DRAWING AMENDMENTS

Fig. 2

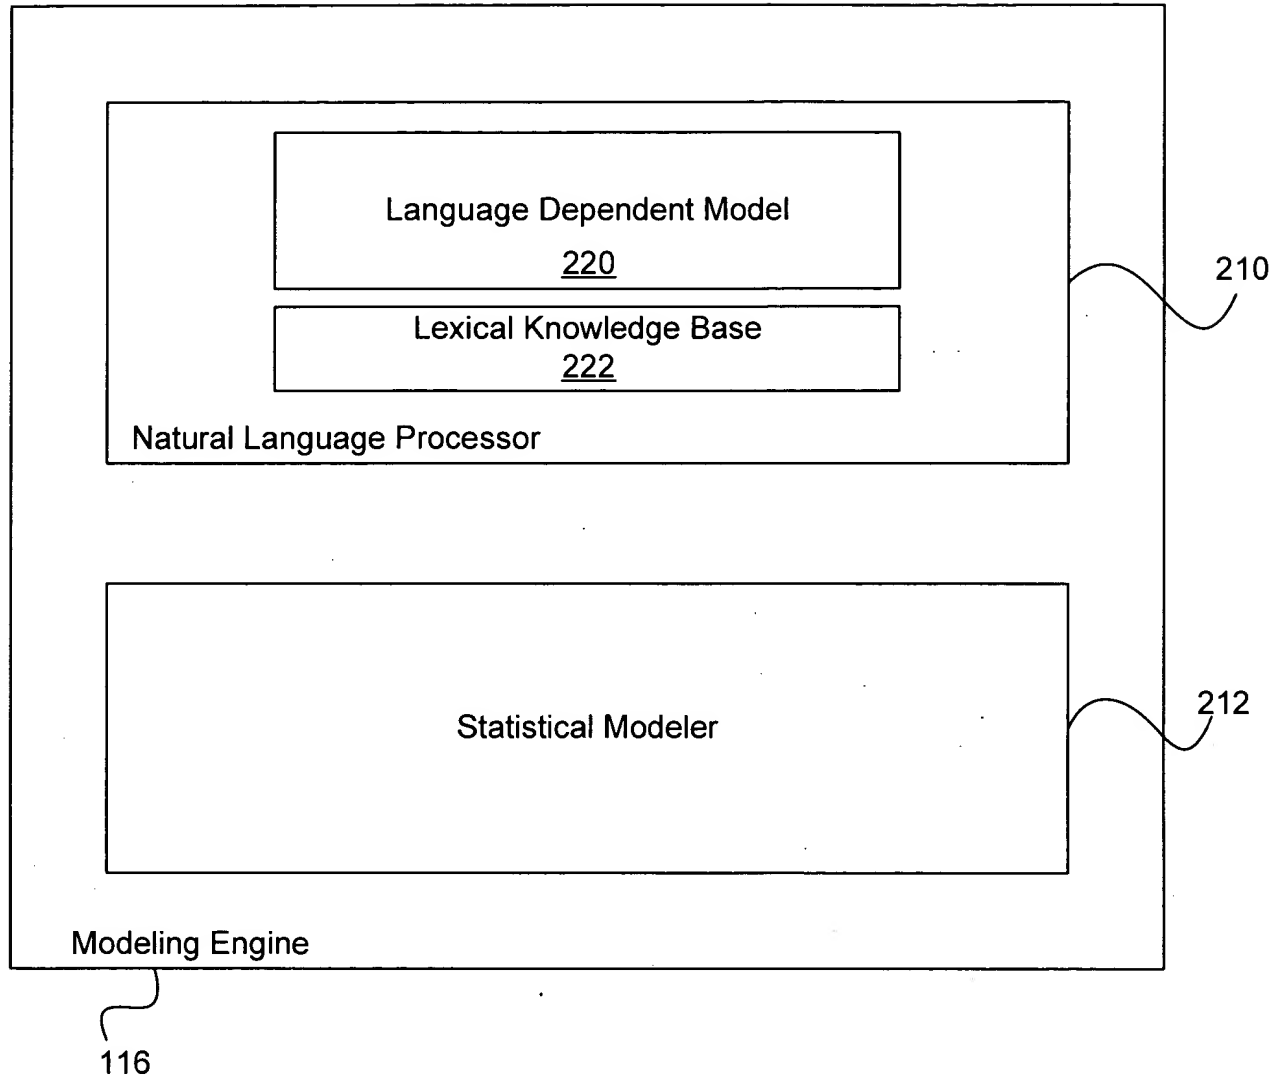
The attached two sheets of drawings set forth changes to FIGS. 2 and 4. The first sheet, which includes FIG. 2, replaces the original sheet including FIG. 2. The second sheet, which includes FIG. 4, replaces the original sheet including FIG. 4. In FIG. 2, previously omitted element Lexical Knowledge Base 222 has been added. Support for this addition is found at page 13, lines 4-7 of the specification. In FIG. 4, the Contact Center, ME and AKB, Data Access Services and Automatic Response elements have been renumbered to match their numbering in FIG. 1.
